**TOWN OF NEWBURGH  
PLANNING BOARD  
TECHNICAL REVIEW COMMENTS**

**PROJECT NAME:** GARDNER RIDGE  
**PROJECT NO.:** 2-29  
**PROJECT LOCATION:** GARDNERTOWN ROAD NEAR GIDNEY AVENUE  
SECTION 75, BLOCK 1, LOT 4.12  
**REVIEW DATE:** 28 JULY 2023  
**MEETING DATE:** 3 AUGUST 2023  
**PROJECT REPRESENTATIVE:** DARREN DOCE, P.E.

**SANITARY SEWER PROFILE**  
 SCALE: 1"=4' VERT.  
 1"=40' HOR.

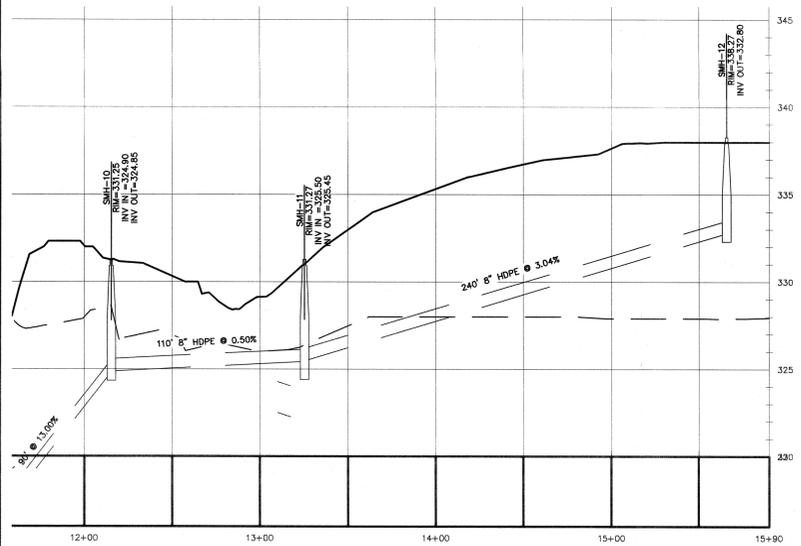
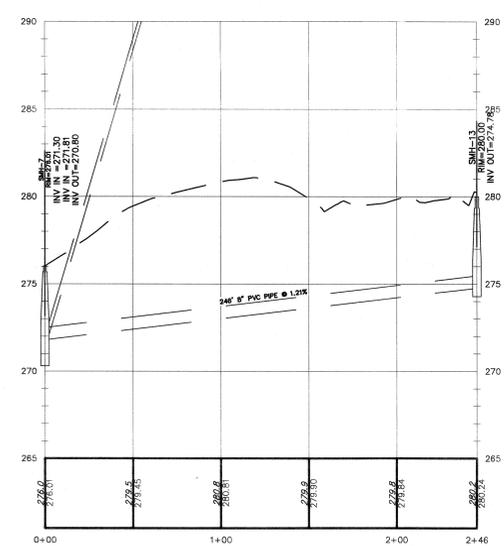
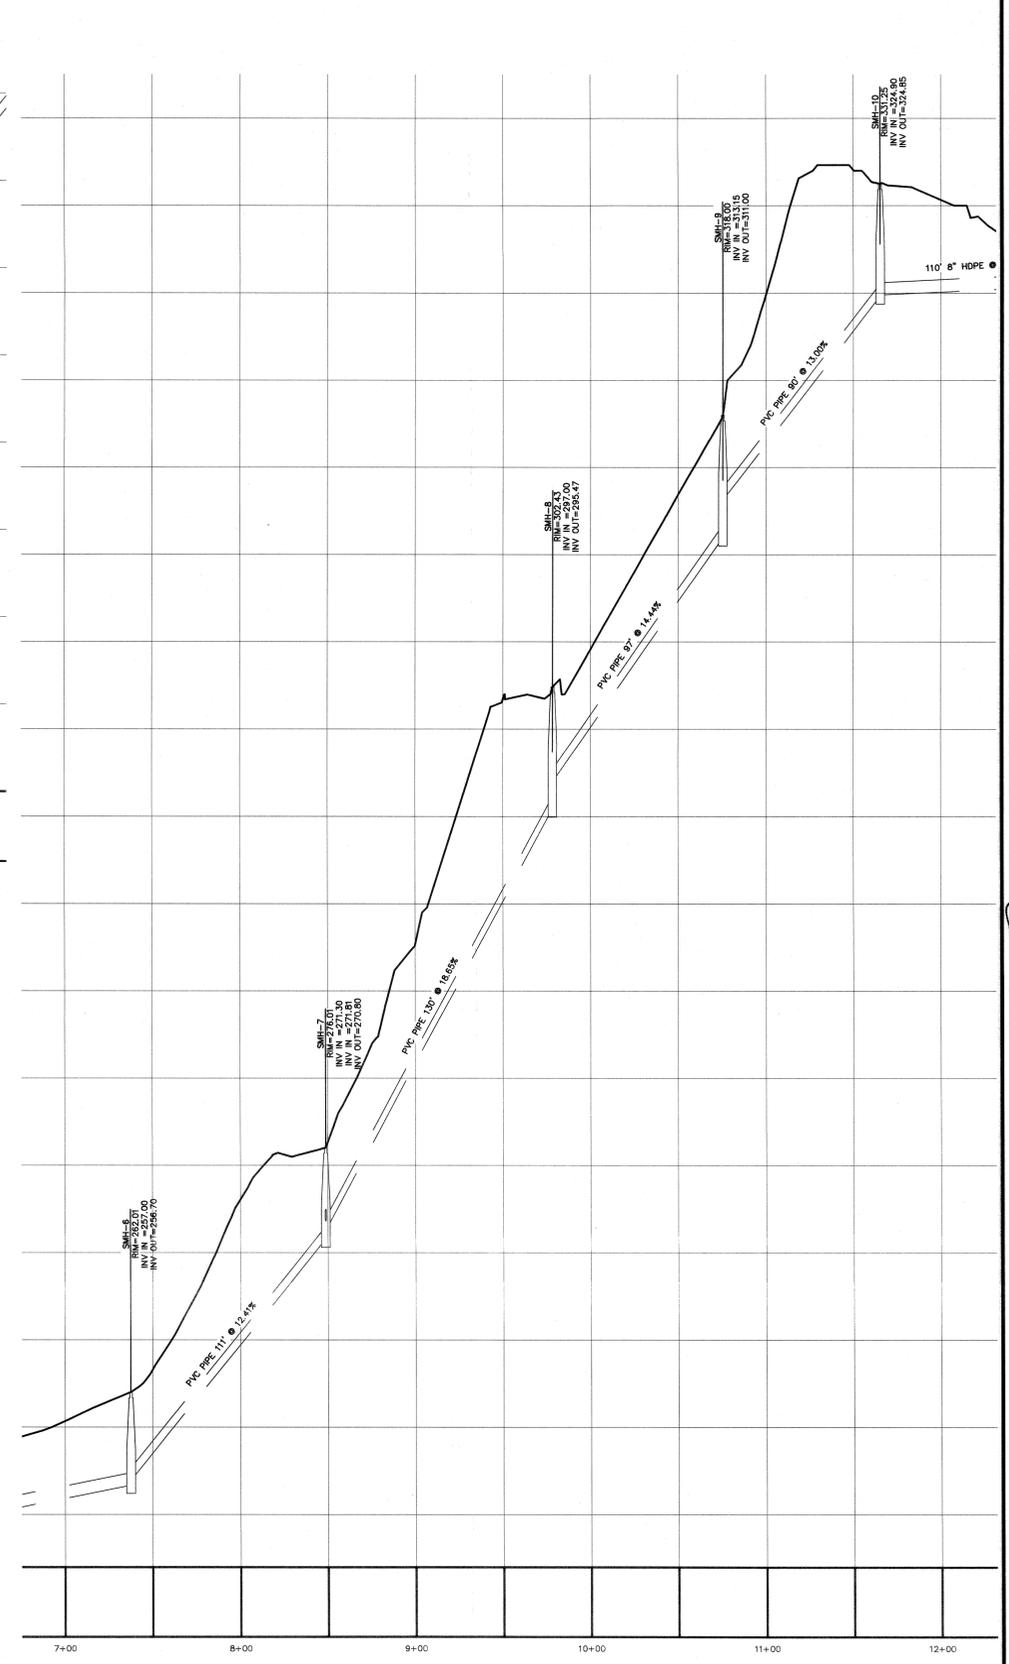
10. The drainage pipe crossing between Sanitary Manhole #4 and #5 is not depicted in profile.
11. Sanitary sewer profile between Manholes #10 and #12 identifies HDPE pipe while all others identify PVC pipe.

14. Emergency spill way should be provided for the extended detention basin.
15. Show all pipe crossings on the sanitary sewer profiles.
16. The outlet on Catch Basin CB3 is incomplete.

**RIP-RAP STABILIZED SLOPE**  
NOT TO SCALE

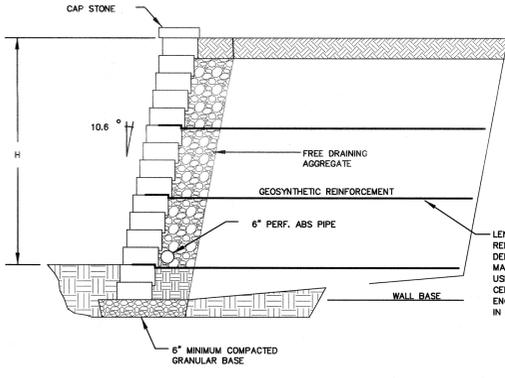
21. Sewer line to the rear of buildings #1 and 2 should have rims and inverts.
22. The Planning Boards attention is called to the proposed rip rap slope, stabilization proposed along Gardnertown Road.

**EMERGENCY ACCESS GATE**  
NOT TO SCALE

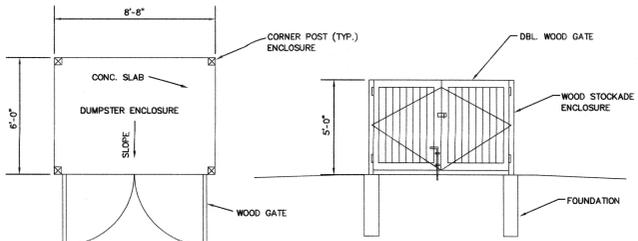
7. The access gates should be depicted at the emergency access road. Coordination of access would be Jurisdictional Emergency Services should be undertaken.

**STORMWATER MANAGEMENT BASIN OUTLET STRUCTURE**  
NOT TO SCALE

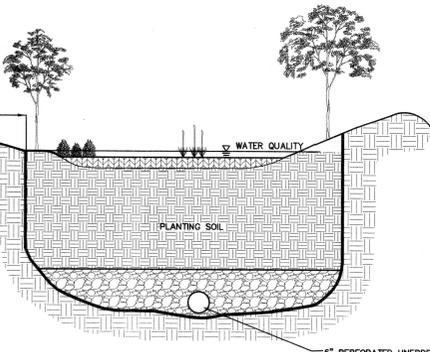
12. Label pipe size from newly proposed bio-retention area to outlet Catch Basin D3 to FES.
13. Outlet Structure #1 is not depicted on the Drainage Plans. Size of pipe from the large bio-detention pond from CB-CS is not depicted.
